## ON-SITE SEWAGE DISPOSAL SYSTEM HOWARD COUNTY HEALTH DEPARTMENT BUREAU OF ENVIRONMENTAL HEALTH

Whitworth Excavating IS PERMITTED TO INSTALL  ALTER   
 ADDRESS: 12680 Clarksville Pike PHONE NUMBER: 410-531-5033  
 SUBDIVISION: Chapel Woods II LOT NUMBER: 3  
 ADDRESS: 11880 Linden Chapel Road PROPERTY OWNER: Allan Homes, Inc  
 SEPTIC TANK CAPACITY (GALLONS): 1500 OUTLET BAFFLE FILTER REQUIRED   
 PUMP CHAMBER CAPACITY (GALLONS): N/A COMPARTMENTED TANK REQUIRED   
 NUMBER OF BEDROOMS: 5  
 SQUARE FEET PER BEDROOM: 210  
 LINEAR FEET OF TRENCH REQUIRED: 270 HOUSE SERVED BY PUBLIC WATER

PLOT PLAN  
CHAPEL WOODS  
LOT 3

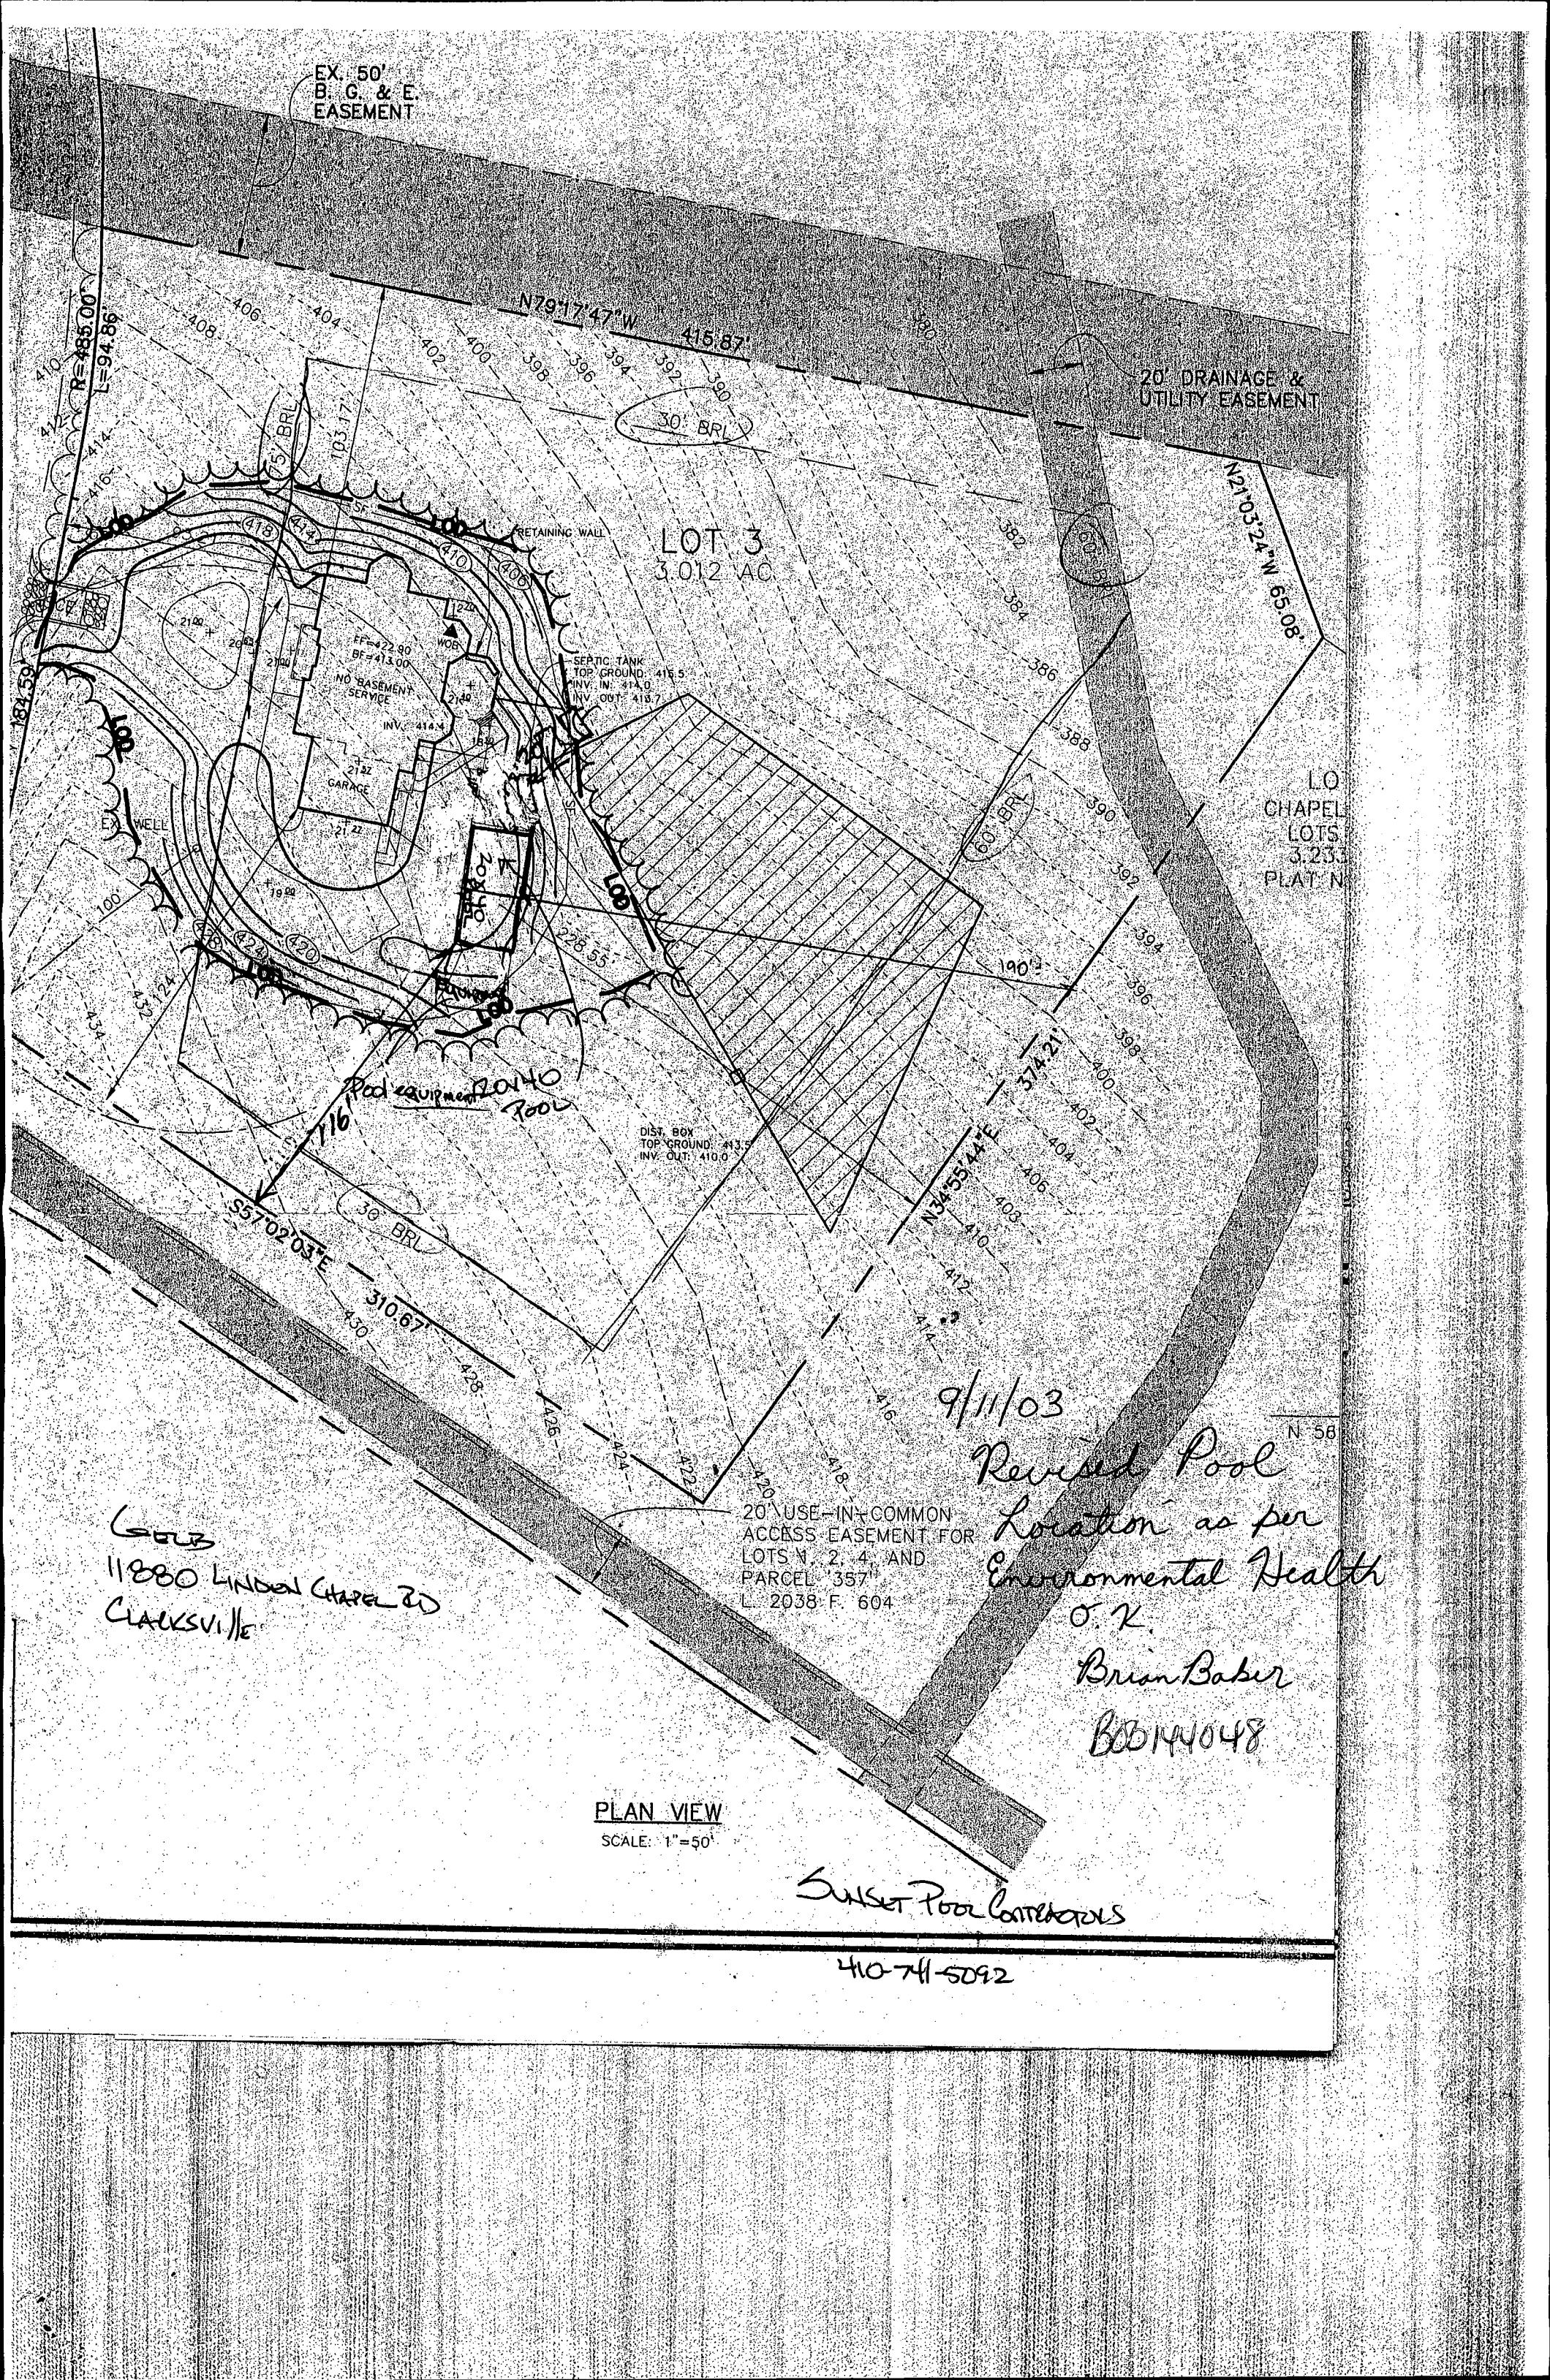
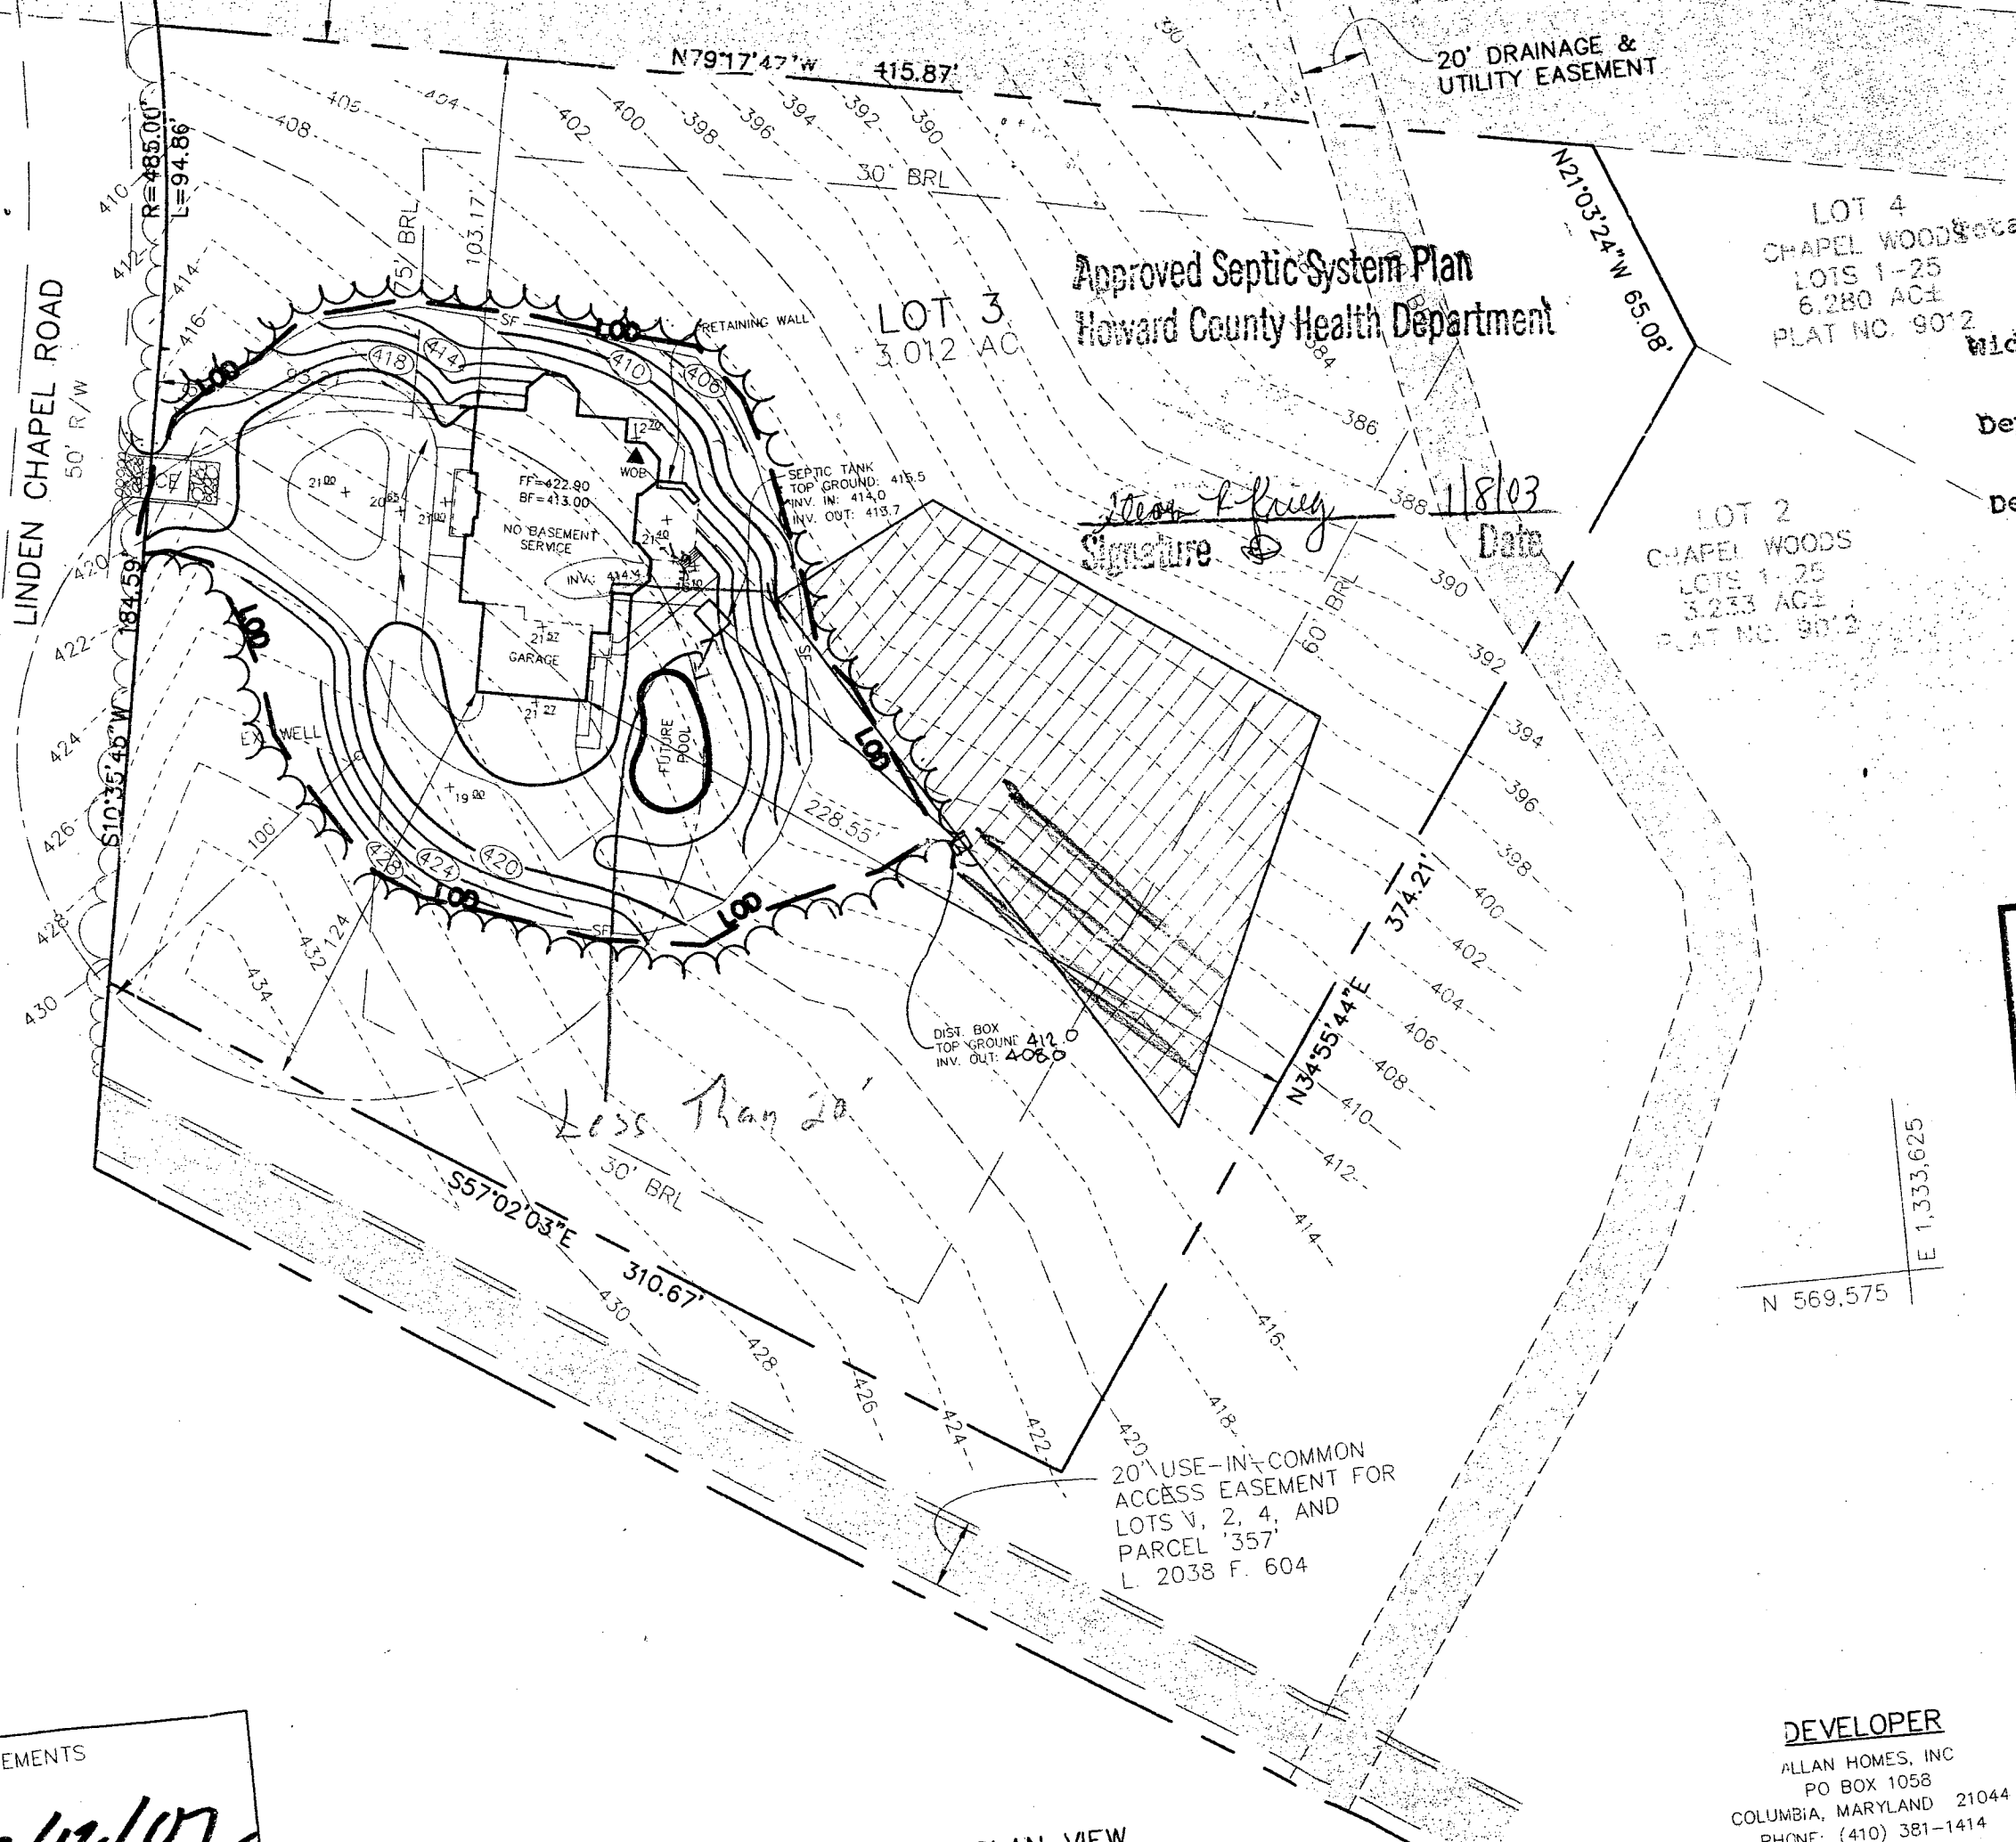
O.K. to Adjust Pool  
 As Shown. The Septic  
 Tank Will Be About  
 11' From the Edge of the  
 Pool Per Field Measurements.

Revised Pool  
Location as per  
Environmental Health  
O.K.
